**RESOLUTION SETTING DATE OF HEARING ON REQUEST FROM BROADLAWNS MEDICAL CENTER TO REZONE PROPERTY LOCATED AT 1801 HICKMAN ROAD FROM "C-0" COMMERCIAL RESIDENTIAL DISTRICT, "R-3" MULTIPLE FAMILY RESIDENTIAL DISTRICT, AND "FW" FLOODWAY DISTRICT TO "PUD" PLANNED UNIT DEVELOPMENT DISTRICT**

Communication from the City Plan and Zoning Commission advising that at their meeting held April 16, 2015, the following action was taken regarding a request from Board of Trustees Broadlawns Medical Center (owner) represented by Jody Jenner (officer) to rezone property located at 1801 Hickman Road.

(21-2015-4.08 & ZON2015-00045)

**BROADLAWNS  
CONCEPTUAL  
PUD PLAN**

USER: SE/SENSE Drawing: P:\Projects\DM\144044\Deliverables\Drawings\1\_CompUD\_Sheet\Sheet\_2.dwg Sheet 2 of 3  
Last Modified: Mar, 16, 2022  
Project: P:\Projects\Deliverables\144044\Deliverables\Drawings\1\_CompUD\_Sheet\Sheet\_2.dwg

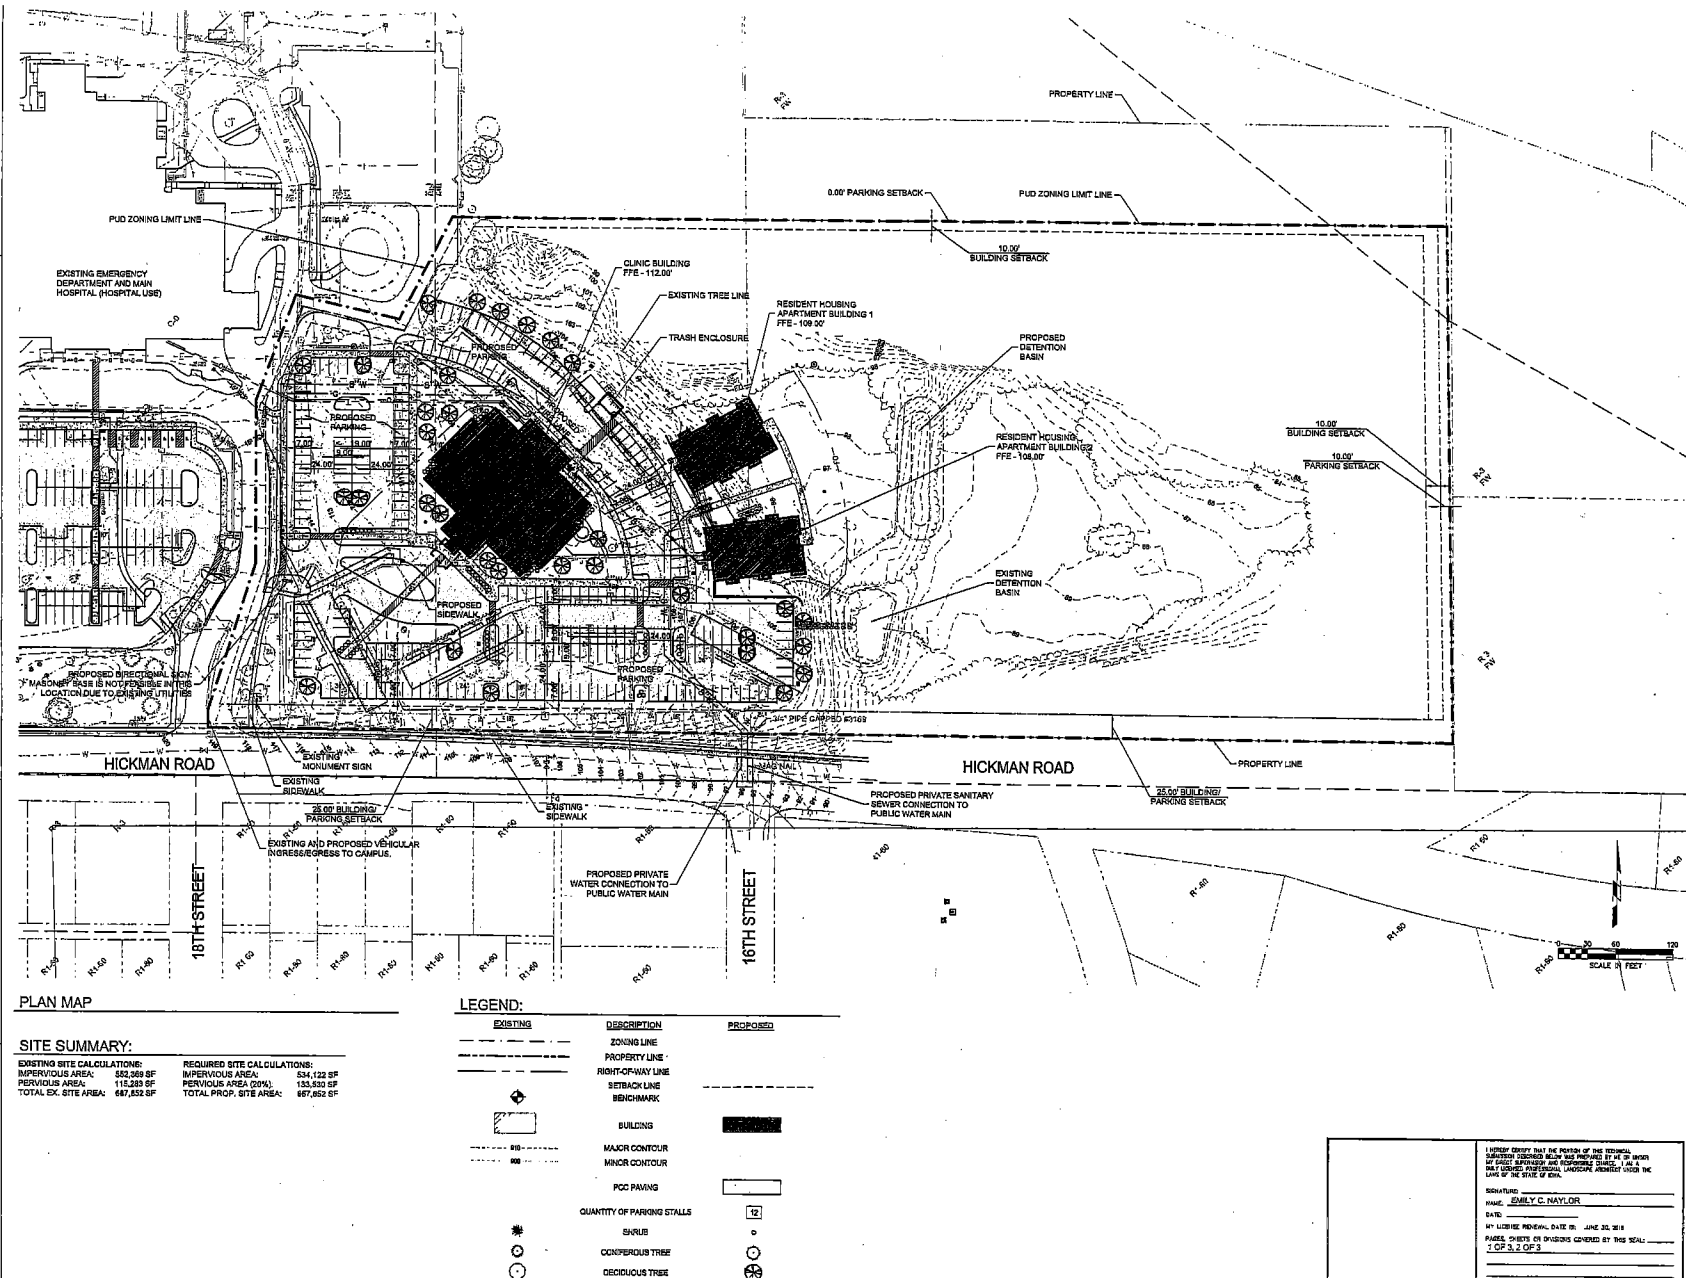
3. The note regarding stormwater management shall also reference City Code Section 106-136 regarding water quality treatment requirements.
4. The notation on Sheet 2 regarding the proposed private sanitary sewer connection shall be revised to state it would connect to the public sewer main.

CLINIC BUILDING - NORTH ELEVATION  
NOT TO SCALE

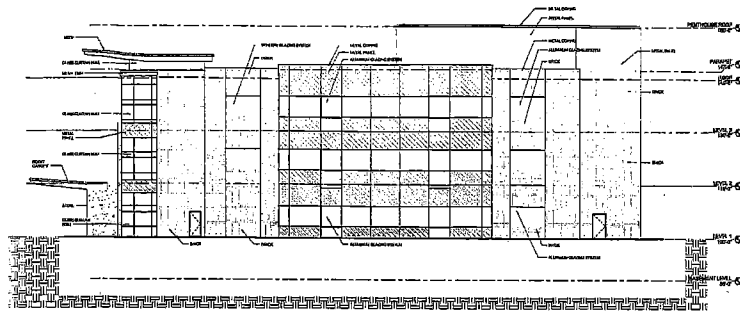
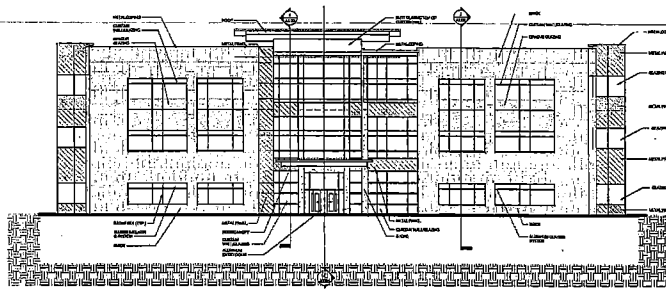
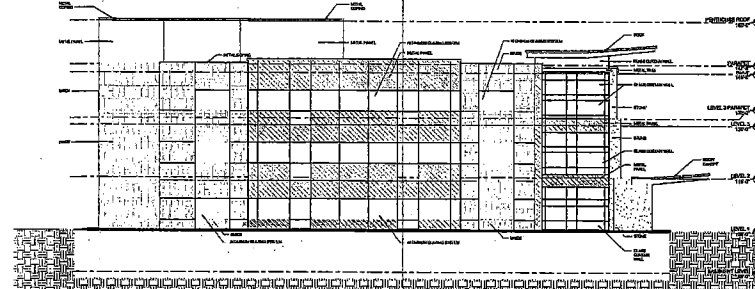
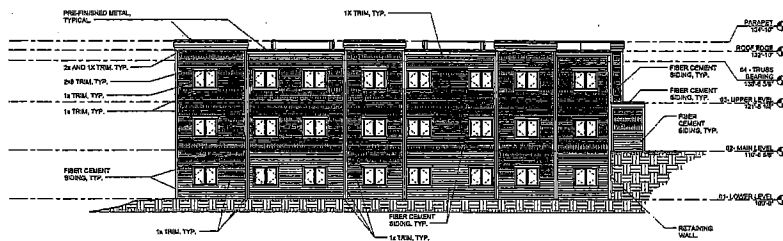
The Conceptual Plan includes a note stating that all rooftop mechanical equipment would be screened from street level view. Staff recommends that this note be clarified to state that all rooftop mechanical equipment that be screened with a design that is architecturally integrated into the building design to the satisfaction of the City's Planning Administrator.

12. The notation on Sheet 1 regarding rooftop mechanical equipment shall be clarified to state that all rooftop mechanical equipment shall be screened with a design that is architecturally integrated into the building design to the satisfaction of the City's Planning Administrator.

RESIDENT HOUSING APARTMENT BUILDING - NORTH ELEVATION  
NOT TO SCALE

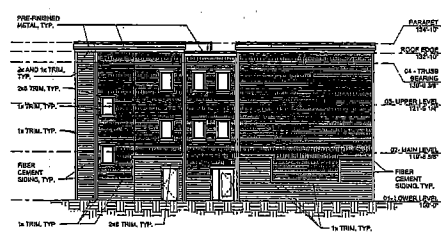
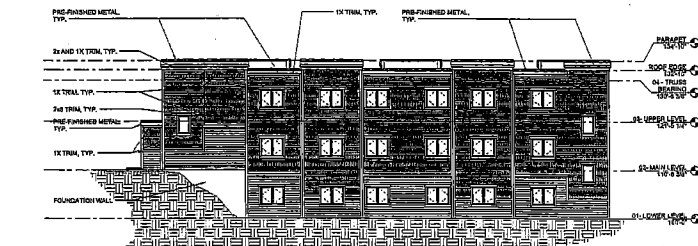
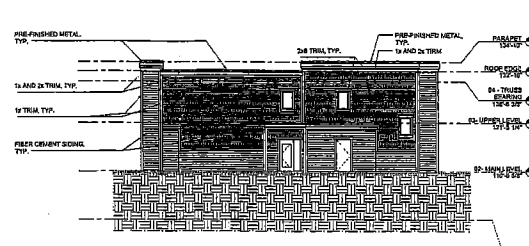
10. The elevations for the multiple-family residential structures shall be revised with a design as approved by the City's Planning Administrator that provides brick or masonry materials on at least at least the bottom floor of each exposed exterior façade and has brick or masonry details on the upper level(s).

11. The elevations for the multiple-family residential structures shall be revised to include additional windows on the west facade to the satisfaction of the City's Planning Administrator.

exposed exterior façade and has some brick or masonry details on the upper level(s). The elevations of the building indicate the north and south side facades of the structures would include a significant number of windows. However, the end facades include very few windows. Staff recommends that the west façade of these buildings, which would face the parking lot and serve at the main entrance, should include additional windows to the satisfaction of the City's Planning Administrator.

10. The elevations for the multiple-family residential structures shall be revised with a design as approved by the City's Planning Administrator that provides brick or masonry materials.

11. The elevations for the multiple-family residential structures shall be revised to include additional windows on the west facade to the satisfaction of the City's Planning Administrator.
